911 Fatherland Street March 16, 2011

Application: Infill

District: Edgefield Historic Preservation Zoning Overlay

Description of Project: The applicant proposes to construct a new two-story house. The house will be thirty-two feet (32') tall and thirty-two feet (32') wide, with a forward-projecting bay and a wrap-around porch. The structure will be clad with cement-fiber siding, a asphalt shingle roof, and a split-faced block foundation.

Job# 0920.11 **PLOT PLAN**

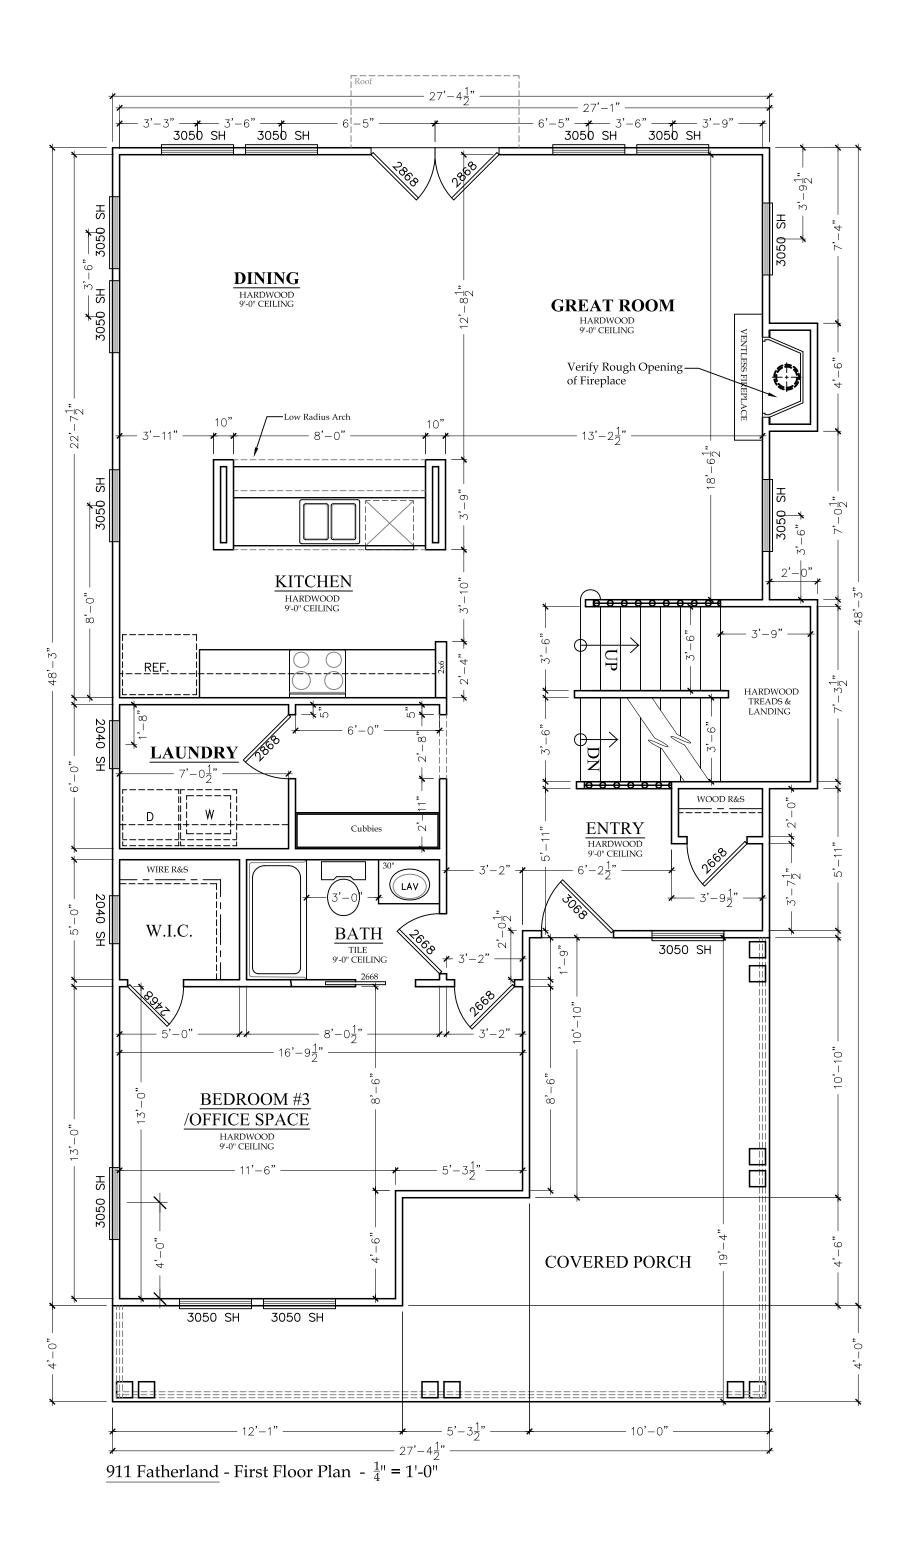
Left and right side setbacks of the proposed new structure will be roughly equal at approximately ten feet (10') on each side, and will maintain the street rhythm established by historic houses on the street. The proposed front setback will be thirty feet (30'). While this setback is the median of the adjacent properties, the structure to the right is not a contributing structure and has a deeper front setback than is typical of historic houses. A smaller front setback, as much as seven feet (7') shorter, would be more appropriate for new construction.

- 1: The front setback be in line with historic houses in the district, as determined on site by the applicant and staff; and
- 2: The depths of the porch be revised to be more compatible with porches on similar house forms; and
- 3: The window proportion on the left side, upperstory, be more compatible; and
- 4: Additional information is provided on the roofing shingle color, porch columns and floor materials, and on the specific window appearance prior to permitting; and
- 5: The site plan and elevations be amended or revised to show all appurtenances and permanent site features, including steps, fences, paving, railings.

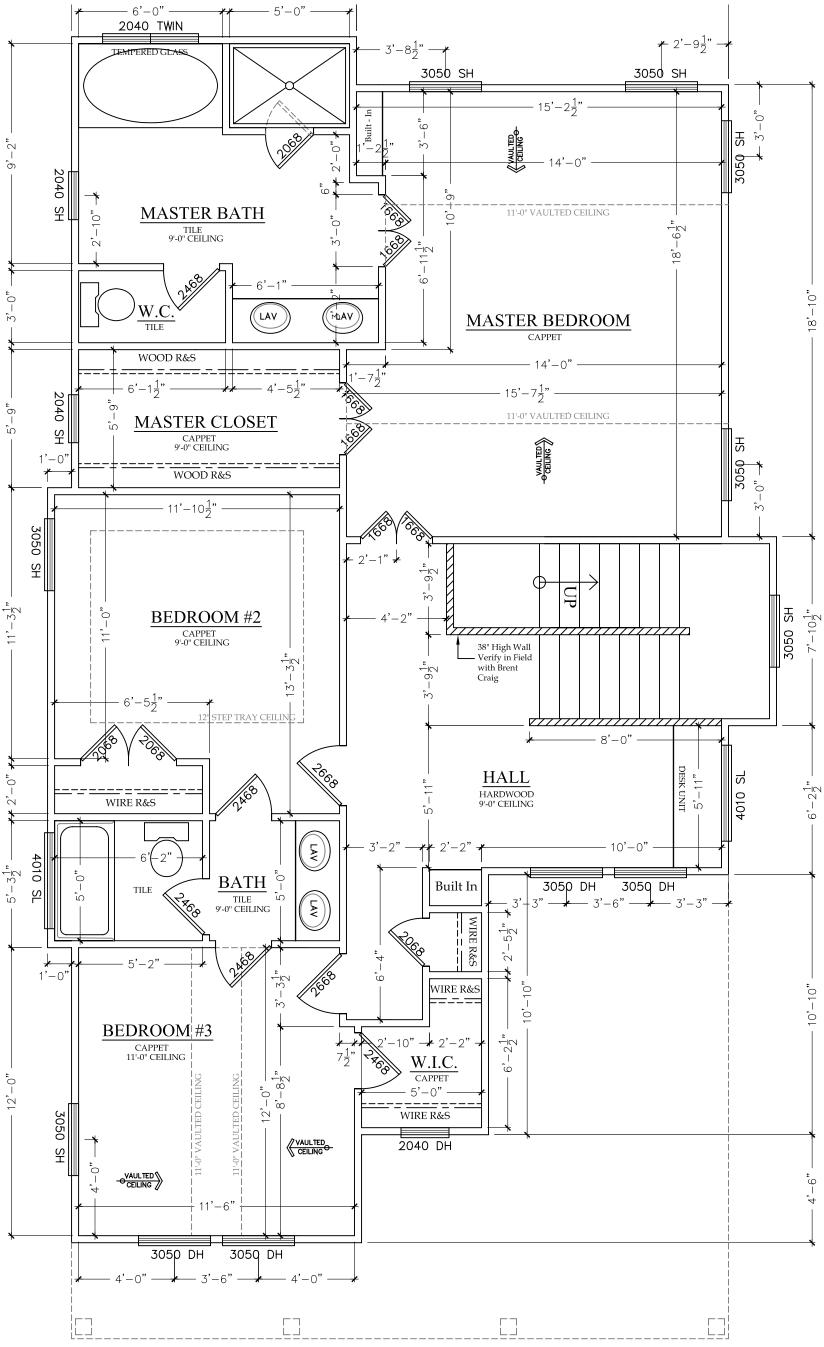
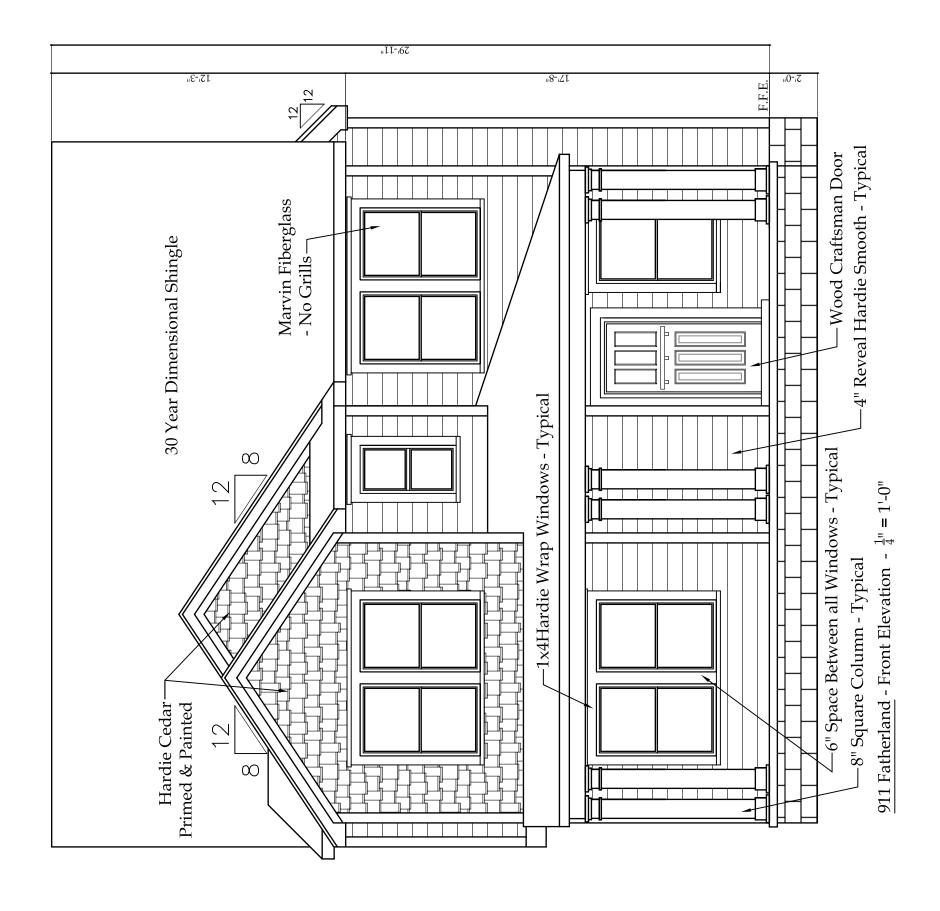
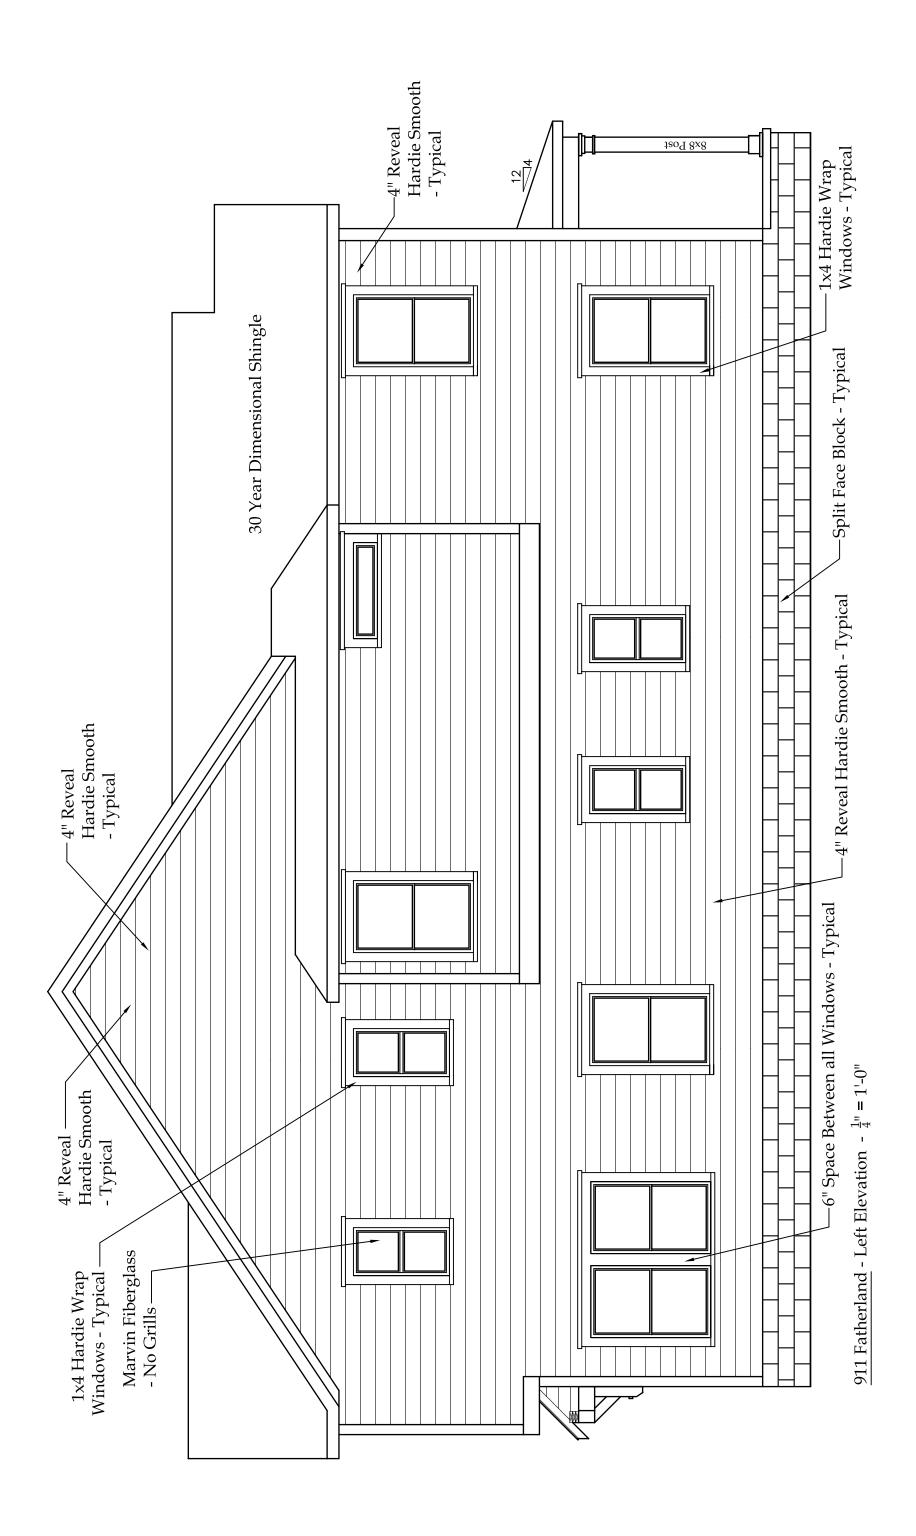
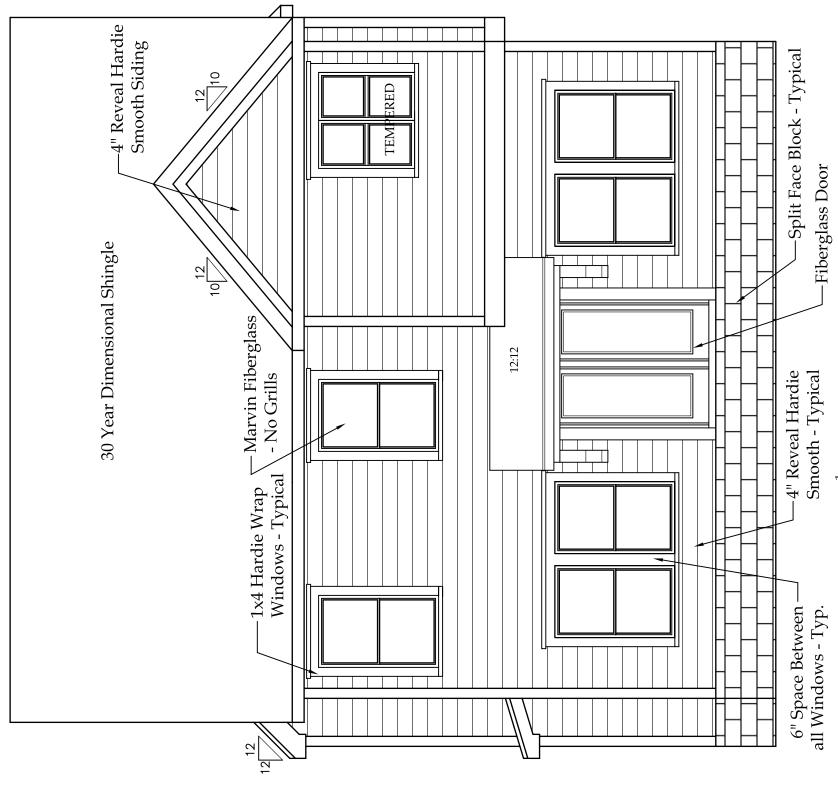
The front and side elevations have numerous openings with double-hung windows, single and in pairs. Almost all windows are rectangular and vertically oriented, with six inch (6") mullions between pairs. On the left elevation, however, there would be a nine inch by forty-two inch (9"x42") transom on the upperstory. Although transoms can be used to help maintain an appropriate window rhythm when standard windows are not practical, the extremely narrow and horizontal proportions of this window are not appropriate. Otherwise, these proportions and the rhythm of windows on the front and side façades are appropriate and meet guideline II.B.2.f.

More information is needed on the roofing shingle color, porch columns and floor materials, and on the specific window appearance prior to permitting. Also, the elevations and site plan need to be amended to show that all paving, porch steps, fences, and other permanent landscape features comply with the design guidelines. If the height of the porch floor above grade requires the front porch to have a railing, it also must be approved by staff prior to construction.
